Agenda Item # 4 SUB-002987-2024

- Subdivision approval to create two (2) legal lots of record from one (1) legal lot of record.

RIVER FOREST SUBDIVISION, RESUBDIVISION OF LOT 32

DETAIL SITE PLAN

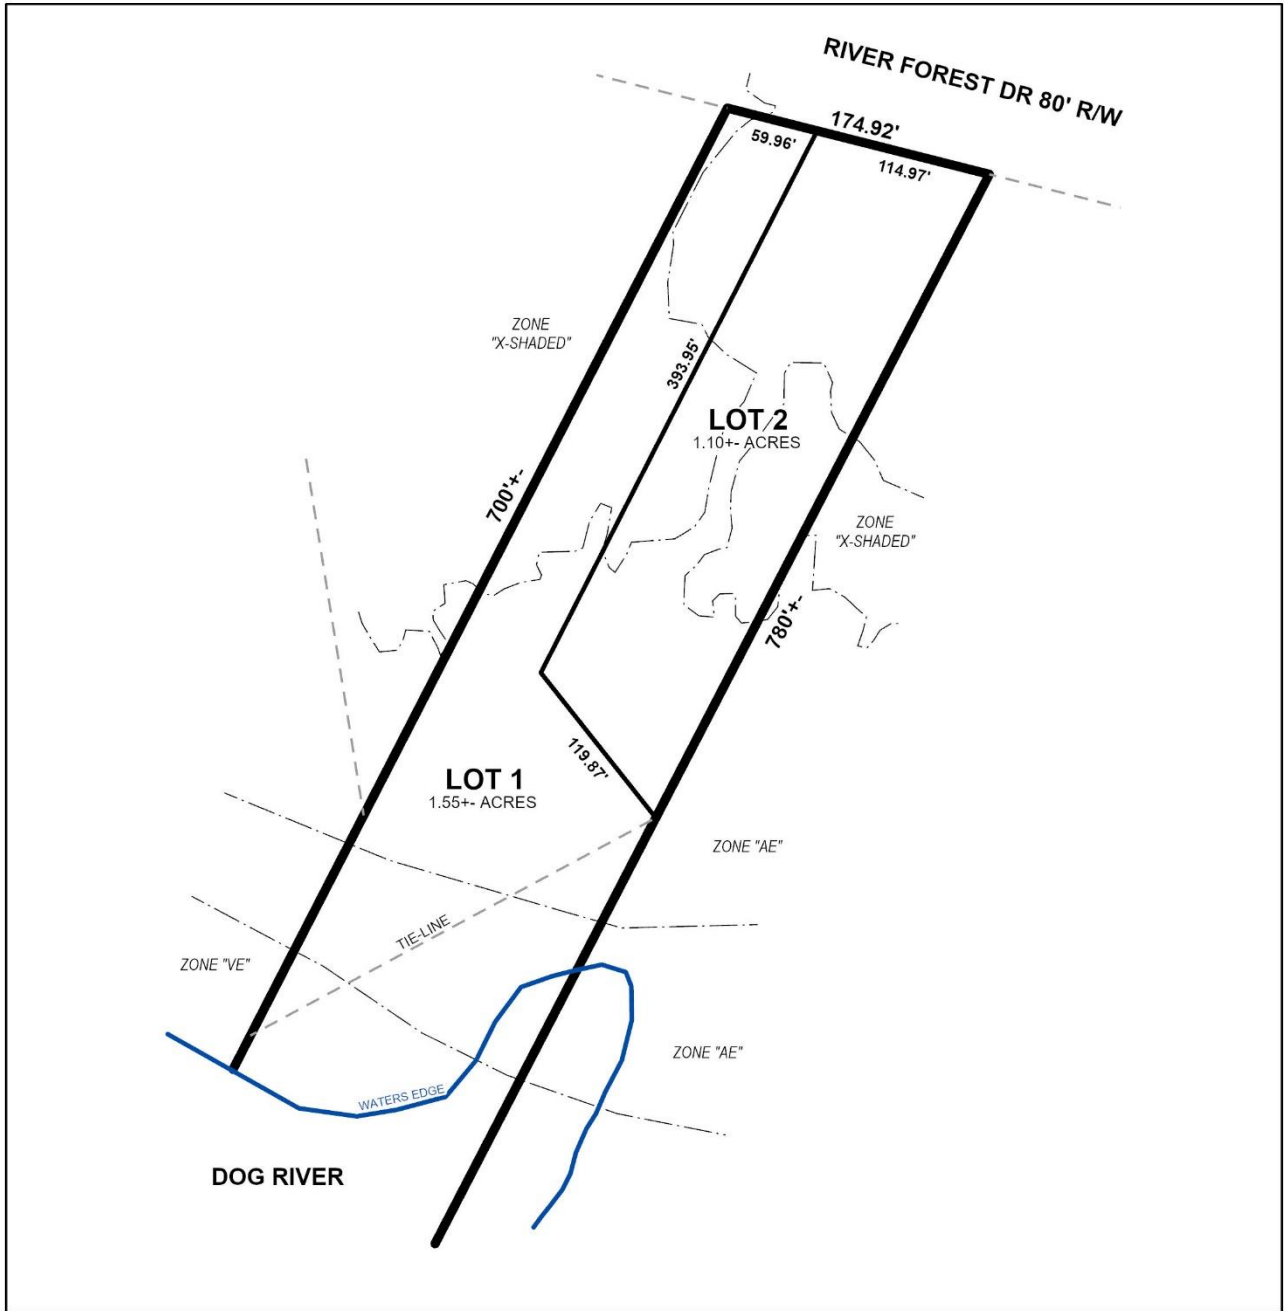
River Forest Road is incorrectly labeled as River Forest Drive on the preliminary plat. If approved, revision of the Final Plat to correctly label River Forest Road should be required.

The proposed lots do not comply with the maximum width-to-depth ratio for newly platted lots. Section 6.C.3. of the Subdivision Regulations limits the maximum depth of lots to no more than 3.5 times their width at the front setback. Long, narrow lots are not uncommon along Dog River, and previous subdivision of the site into lots that also did not meet this requirement may suggest that a waiver of Section 6.C.3. would be appropriate.

Proposed Lot 1 may be considered a "flag lot," with a 59'±-wide "pole" providing access to River Forest Road. Such lot designs are discouraged by Section 6.C.9.(b) of the Subdivision Regulations unless similarly shaped lots are common within the vicinity of the subject site, or where unusual circumstances exist. Flag lots are not uncommon within the vicinity of the subject site; therefore, a waiver of Section 6.C.9.(b) may be appropriate.

No front yard setback is illustrated on either proposed lot. If approved, revision of the Final Plat to illustrate a 25-foot front yard setback along River Forest Road where each lot is at least 60 feet in width should be required, in compliance with Section 64-2-5.E. of the Unified Development Code (UDC) for lots in the R-1 Suburban district.

1. Revision of the plat to correctly label River Forest Road;
2. Retention of the lot sizes in square feet and acres on the Final Plat, or provision of a table on the Final Plat with the same information;
3. Revision of the plat to illustrate the required 25-foot front yard setback along River Forest Road where each lot is at least 60 feet in width;
4. Compliance with all Engineering comments noted in this staff report;
5. Placement of a note on the Final Plat stating the Traffic Engineering comments noted in this staff report;
6. Compliance with all Urban Forestry comments noted in this staff report; and
7. Compliance with all Fire Department comments noted in this staff report.
